**PLANNING COMMISSION AGENDA
APRIL 7, 2022 – 6:30 P.M.**

**CITY OF LA VISTA
PLANNING DIVISION
RECOMMENDATION REPORT**

NEBRASKA MULTI-SPORT COMPLEX
SITE & INFRASTRUCTURE PLANS

Figure 13. Event Site-generated Trips

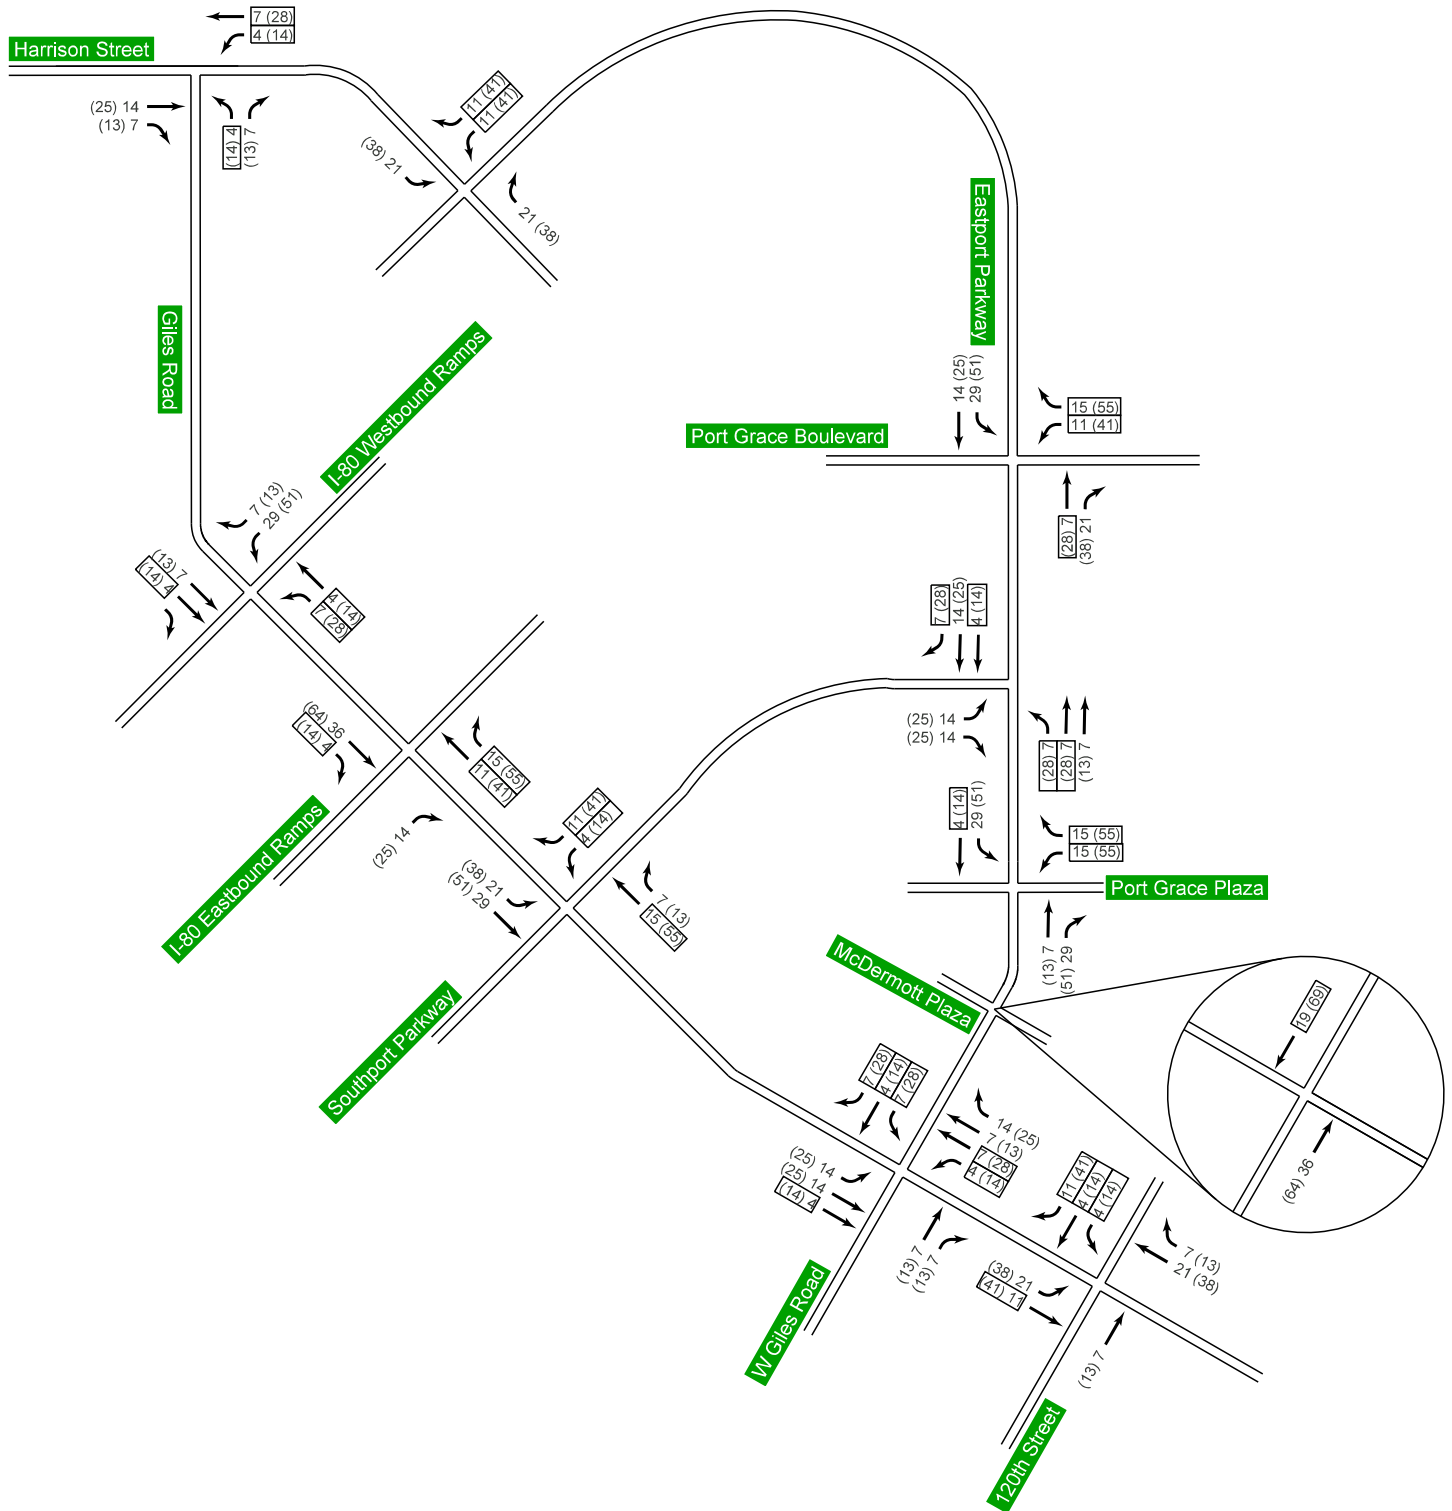
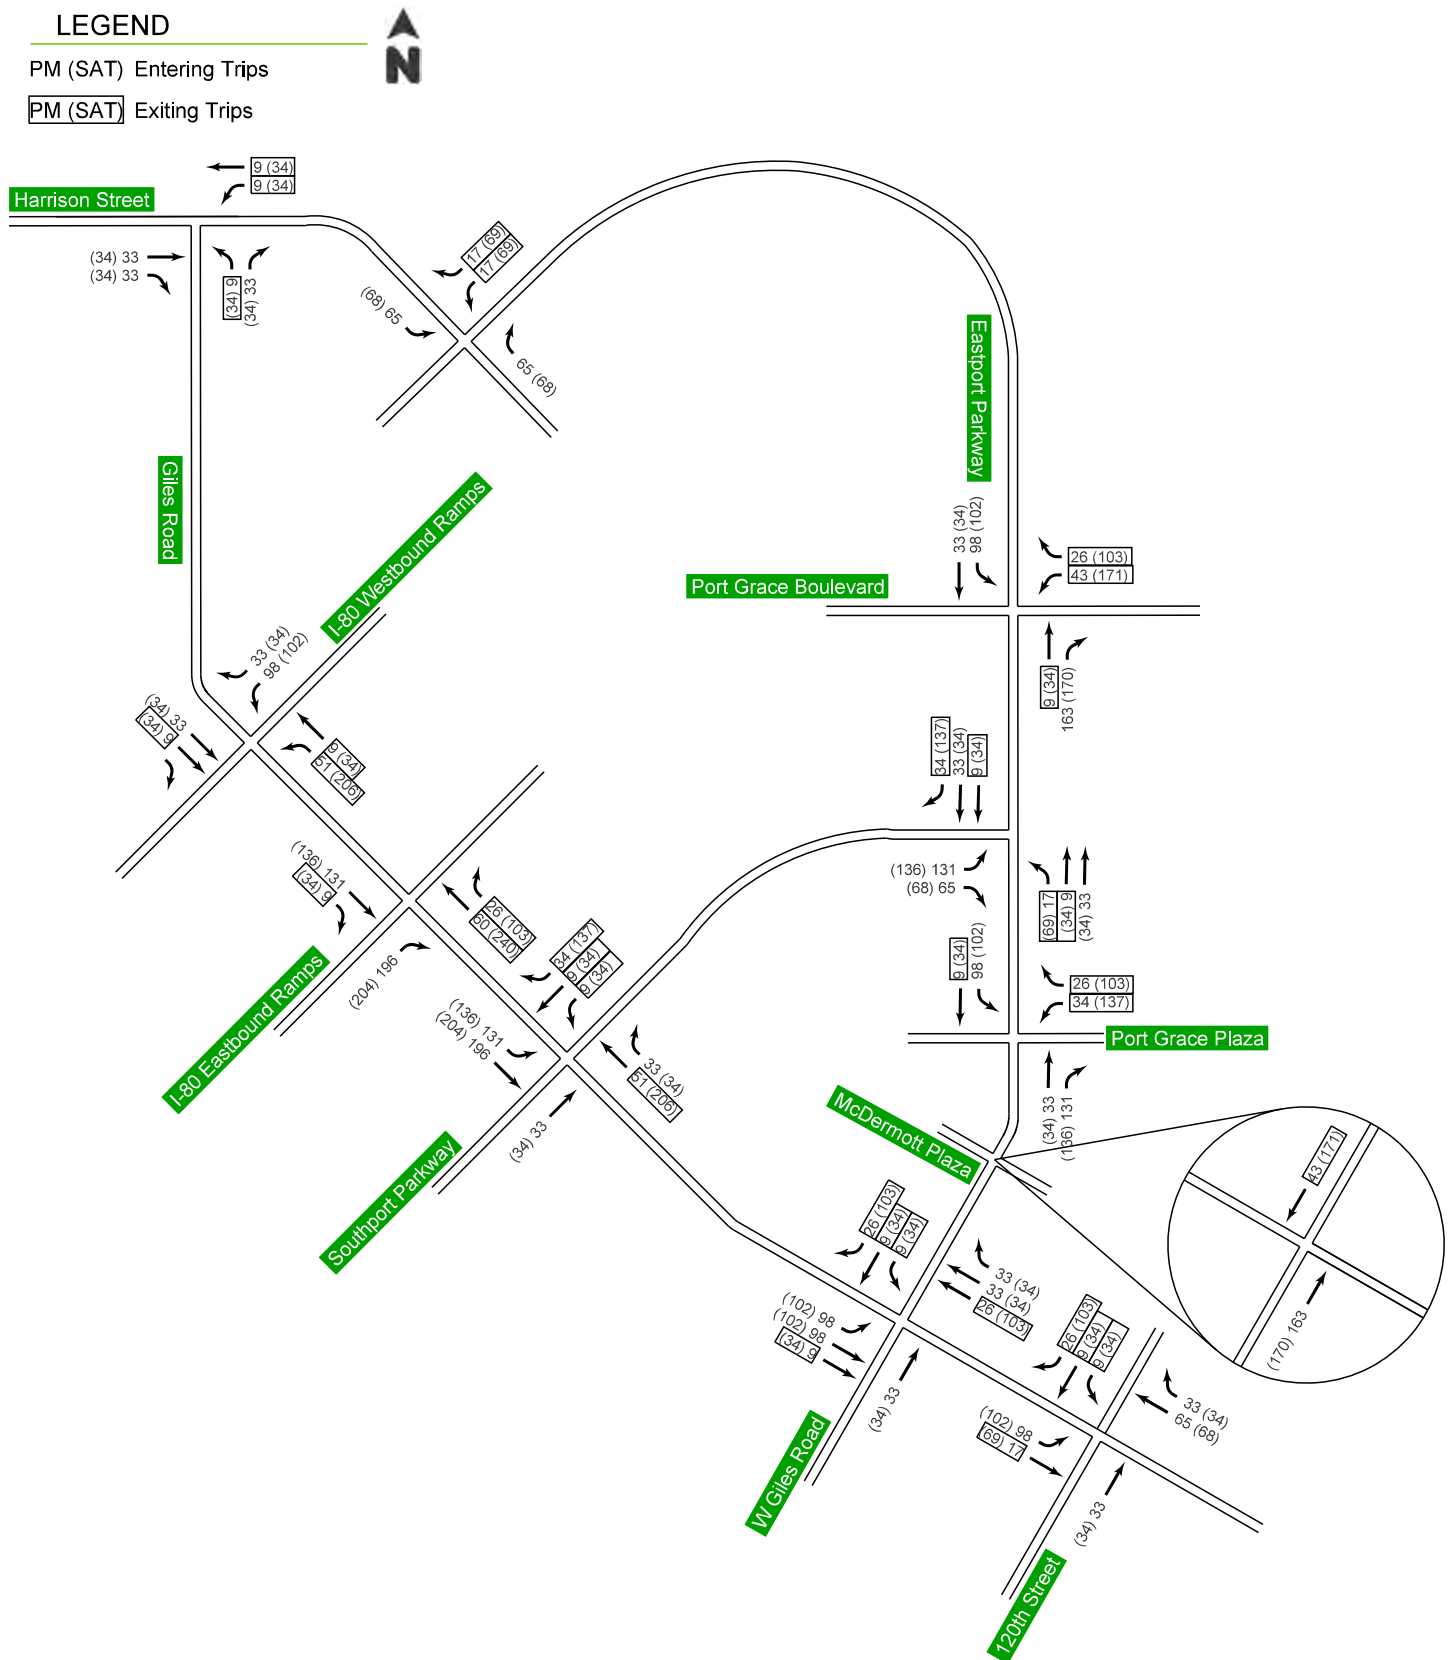
8. Page 25 & 26 / Figure 12 & Figure 13: At the intersection of 120th Street with Giles Road, trip generations are shown on the northbound left-turn movement. Trip distributions figures show these site -generated volumes should be through movements.
Please have the applicant update Figure 12 and Figure 13 to show the correct site-generated trips at the intersection of 120th Street and Giles Road.

Figure 19. 2050 plus Event Traffic Volumes

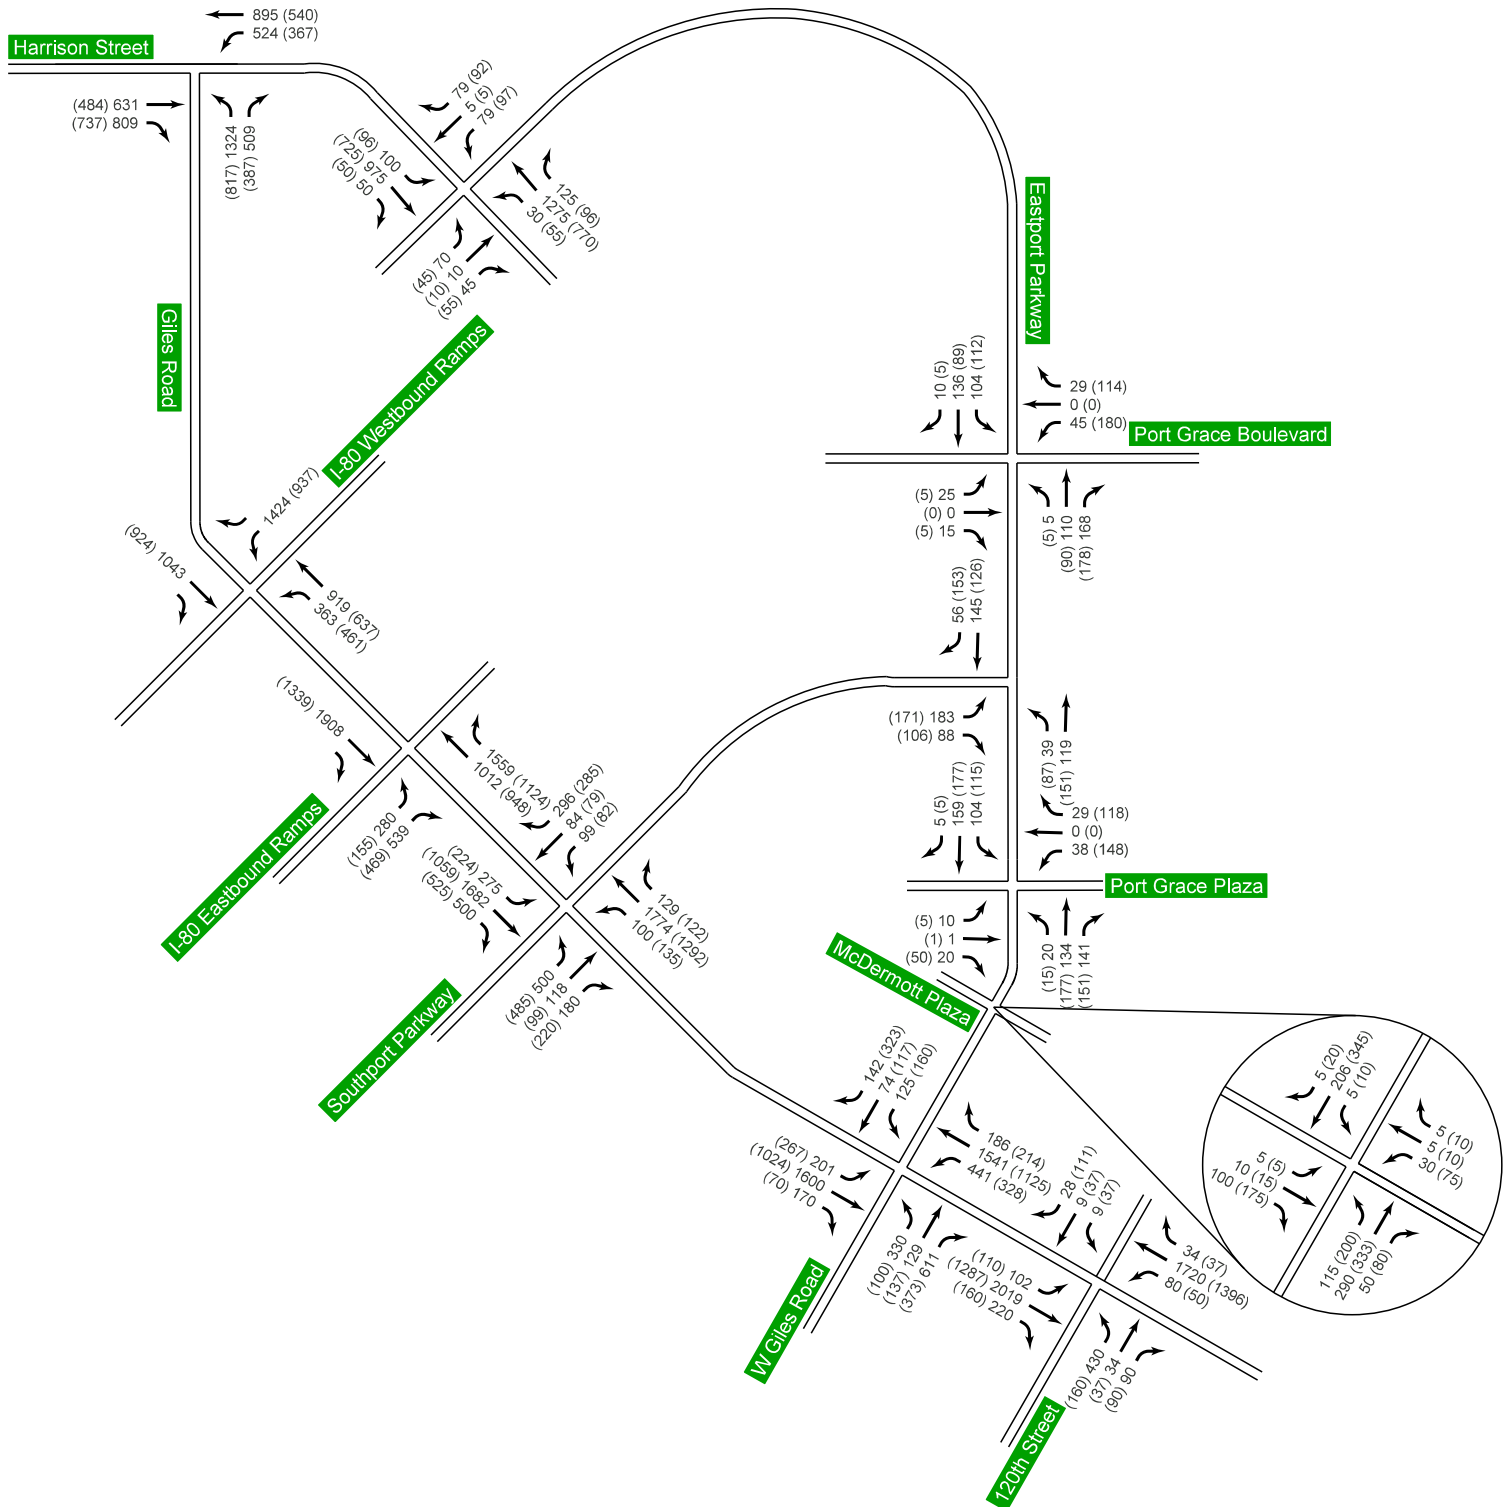
9. Page 35 / Figure 19: Figure 19 is labeled incorrectly.
Please have the applicant update the figure name from 2025 to 2050.
10. Page 44 / 120th Street and Giles Road: List of improvements should include installing a new traffic signal for the proposed north leg (SW corner). Modifications may be required to the NE signal pole to accommodate the site drive and the northbound dual-left turn lanes.
Please have the applicant add install traffic signal/traffic signal modifications to
